## **HISTORIC PRESERVATION BOARD**

### **HISTORIC PRESERVATION BOARD AGENDA** **May 7, 2014 – 5:00**

**SITE VISIT AND PUBLIC HEARING  
638 CONGRESS STREET**

**WORKSHOP (continued from 4/16)  
EVERGREEN CEMETERY**

2 SKETCH ELEVATION OF COLUMBARIUM WALLS  
NTS

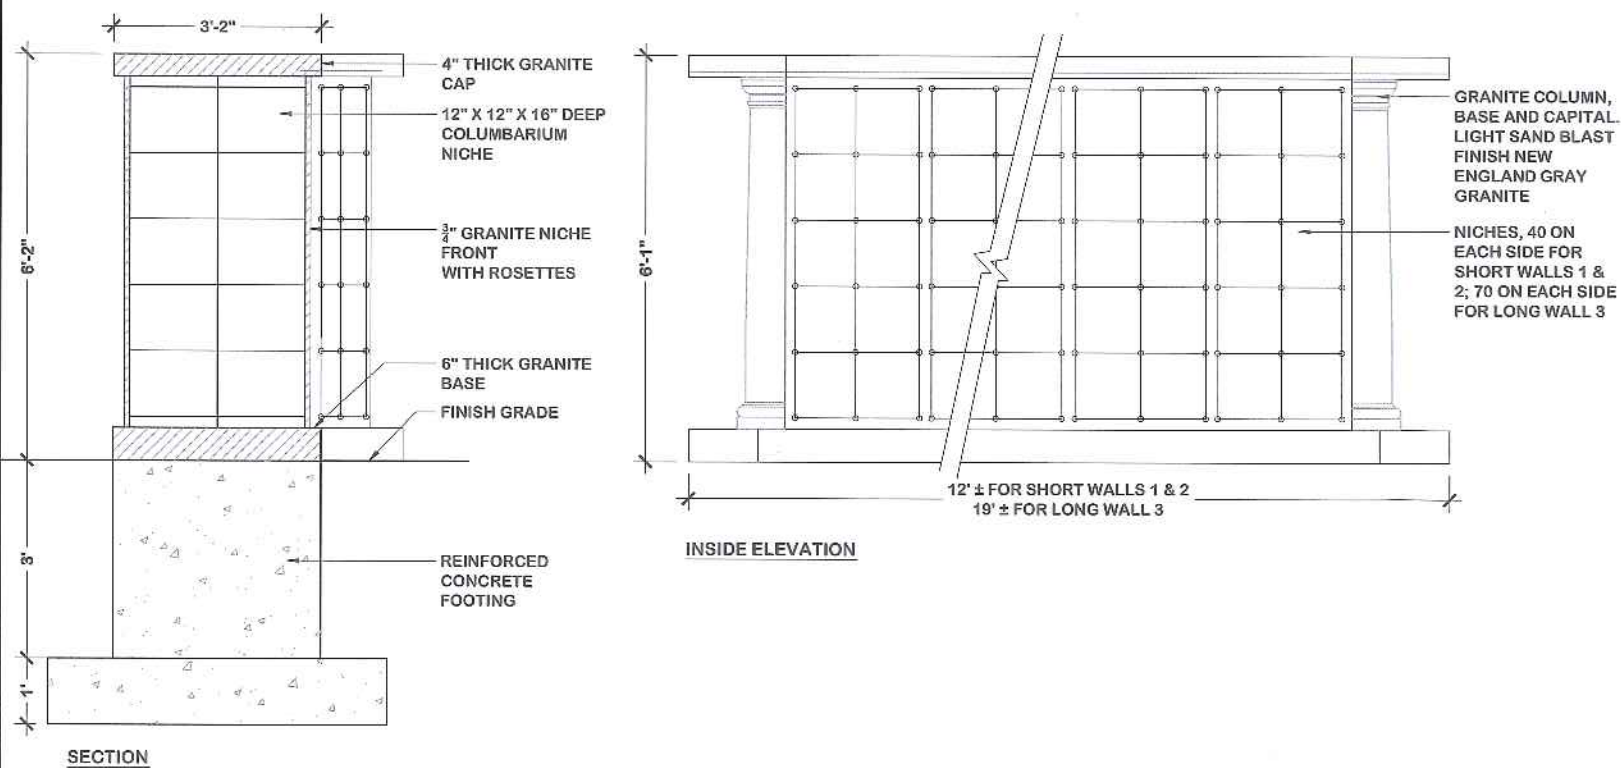
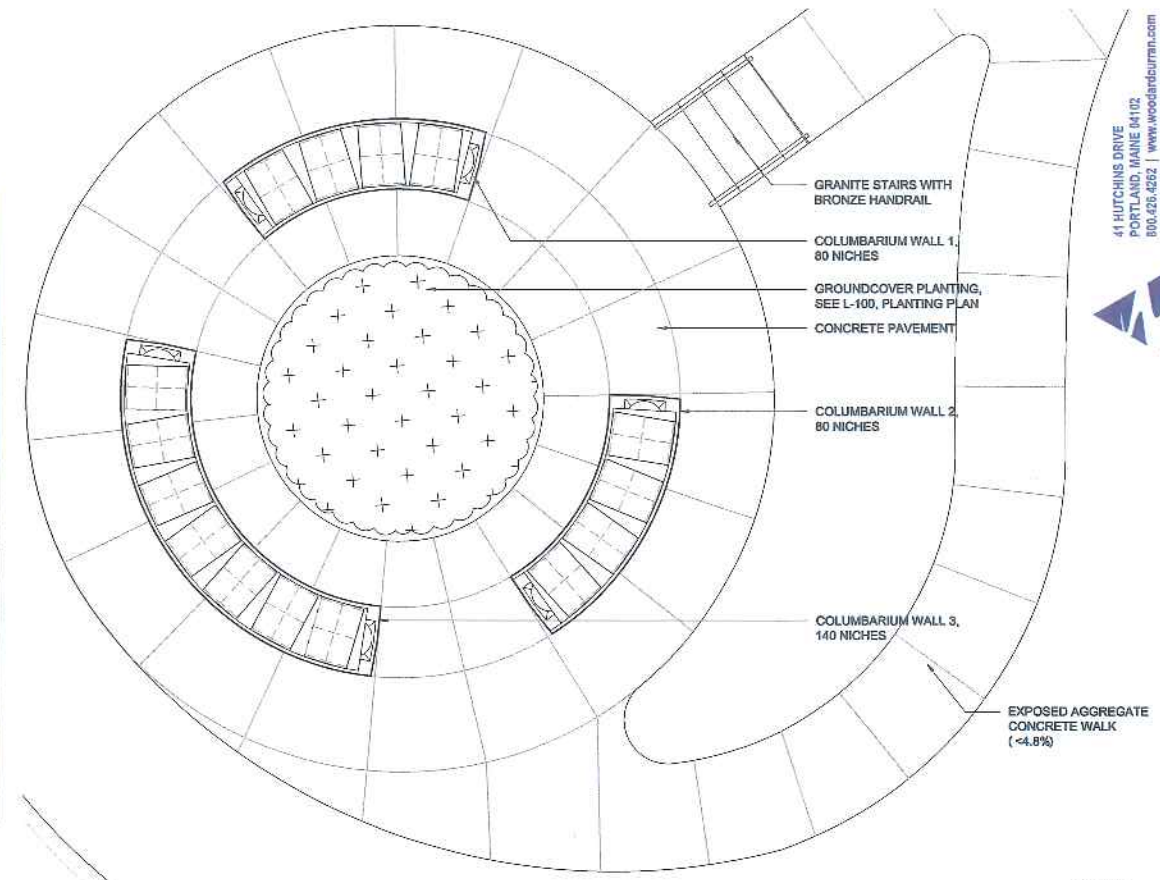
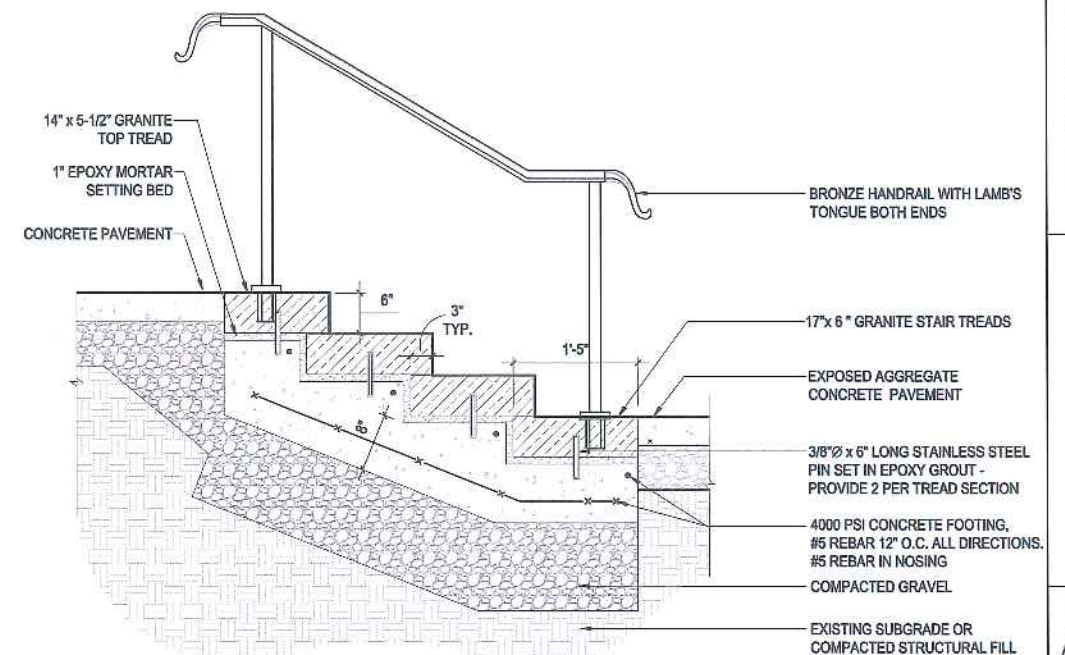
The consultants did ask staff to briefly characterize the concerns in order that they might be prepared for Wednesday's discussion. Staff explained that in addition to the concerns identified at the site walk (the presence and placement of apple trees at the cemetery entrance and the design of the columbarium), Board members expressed concerns about the relationship of the circular drive to the columbarium.

The columbarium design is also being modified to address comments provided. The half columns originally proposed for the ends of each columbarium wall will be eliminated, and the granite base will be made more substantial. We are currently reviewing the changes with a columbarium manufacturer, and updated elevations will be provided for review during the May 7 workshop.
